WR1D Schematic Ver :3A

QUANTA COMPUTER		
PAGE LIST		
Title	Document Number	Rev
Size	WR1D MAIN BOARD	3A
Date: Friday, August 25, 2006	Sheet 2 of 43

ES1 TO ES2 CHANGE LIST

Title: **Yonah CPU (HOST BUS)-1**

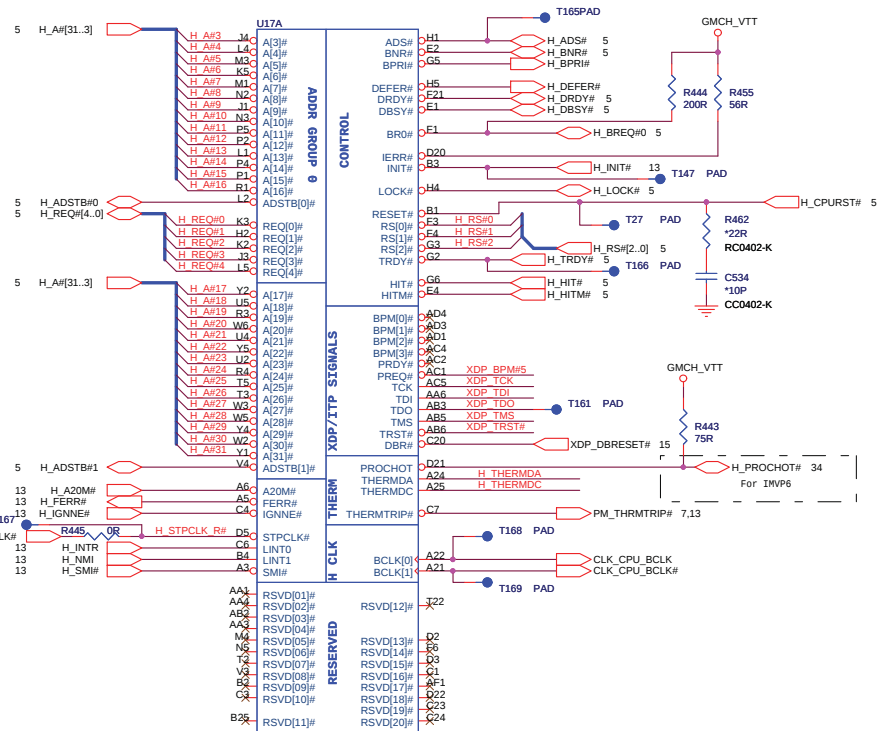
EC59

EC59 PAGE3---Change THRMTRIP# net for low temperature can't boot issue.
EC60 PAGE31---Add C790,C791 for 3V singnal drop issue when initial boot.
EC61 PAGE37---Reserve PC136,PC177,PC178,PC181 and C796 for keep VCC 1.8 at right level when run 3D mark.

Title		
BUZZER & AUDIO/BOARD		
Size	Document Number	Rev
Custom	WR1D MAIN BOARD	3A
Date: Friday, August 25, 2006		
Sheet 26 of 43

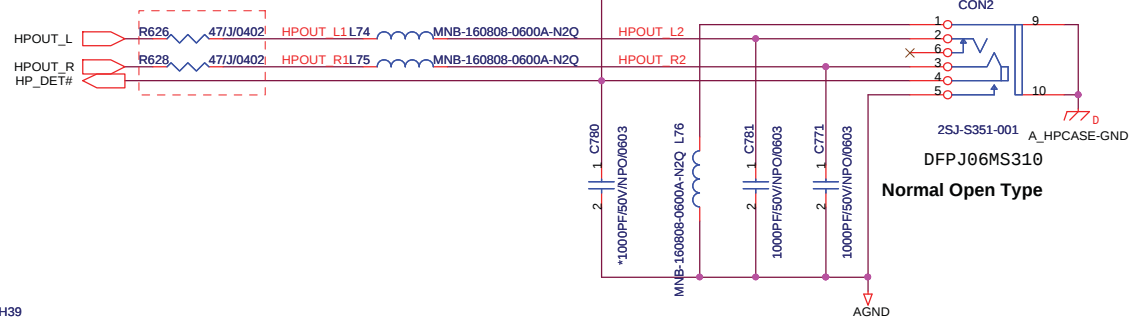
Change resistors dimension from 0603 to 0402 to prevent PCB bending cause solder and components crack issue!

Title	LAN(TR&CONNECTOR) &SATA HDD +ODD
-------	----------------------------------

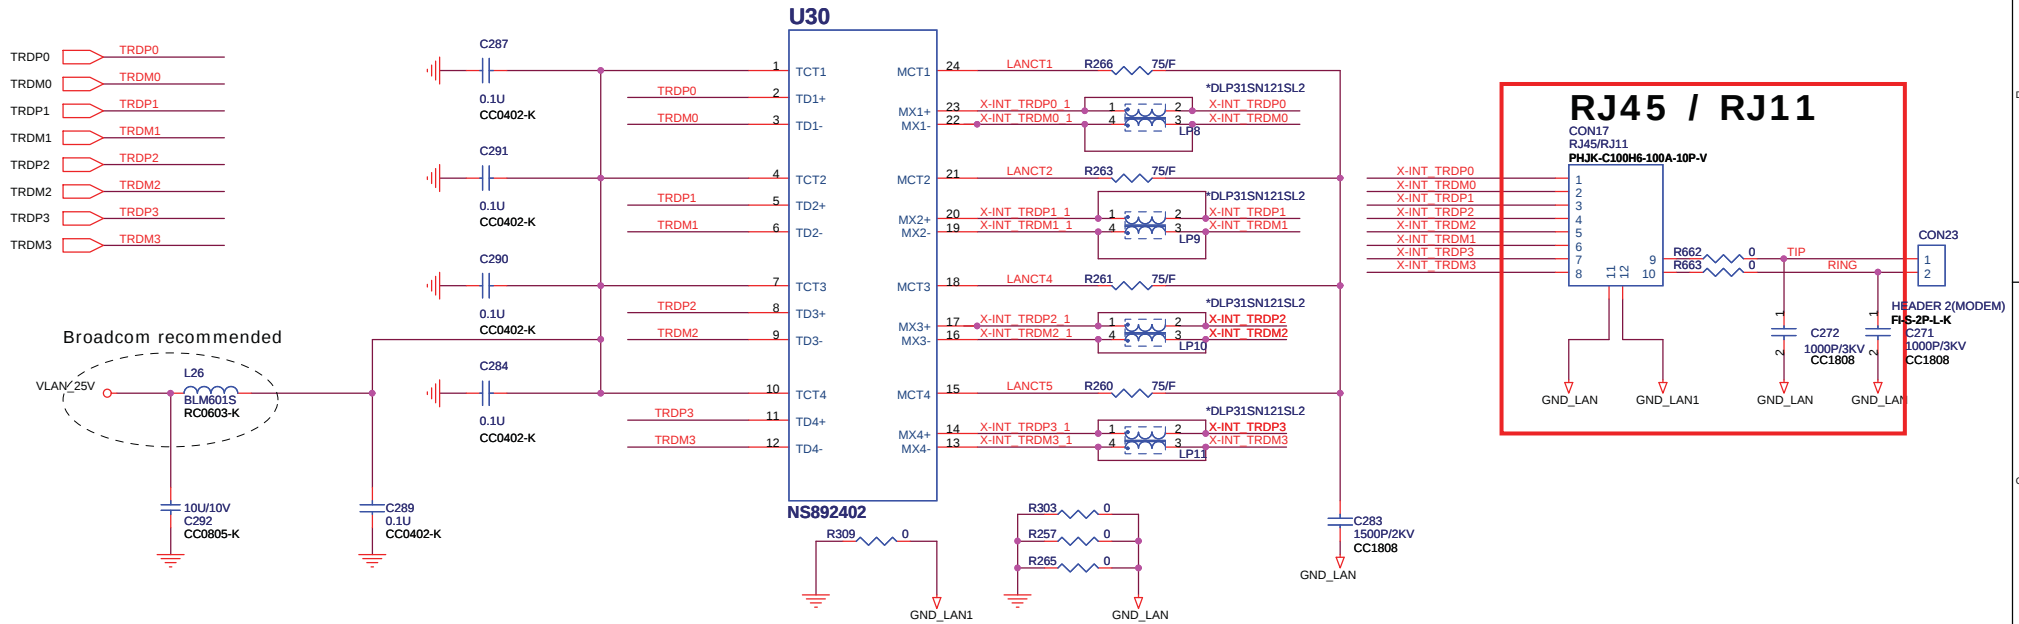
- Pin assignments for ExpressCard connector is wrong. Please change 7 pin from RSVD#1 to SMBCLK. Please change 8 pin from SMBCLK to SMBDATA. Please change 9 pin from SMBDATA to 1.5V.
- Please apply 100K pull-up resistor to CPPE#.
- Please apply 100K pull-up resistor to CPUSB#.
- Please apply capacitor (0.1uF and 10uF) to +3.3V_NC1, +3.3VAUX_NC1 and +1.5V_NC1 respectively.

HDMI PORT

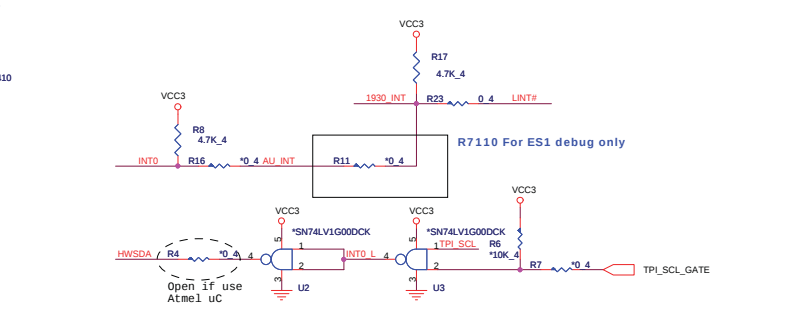
Mount R63, keep R64 NC at the beginning
Remove R63, mount R64 after VBIO5 add PRGM# function.

Silicom request need to add this MOSFET to avoid ATMEl latch up
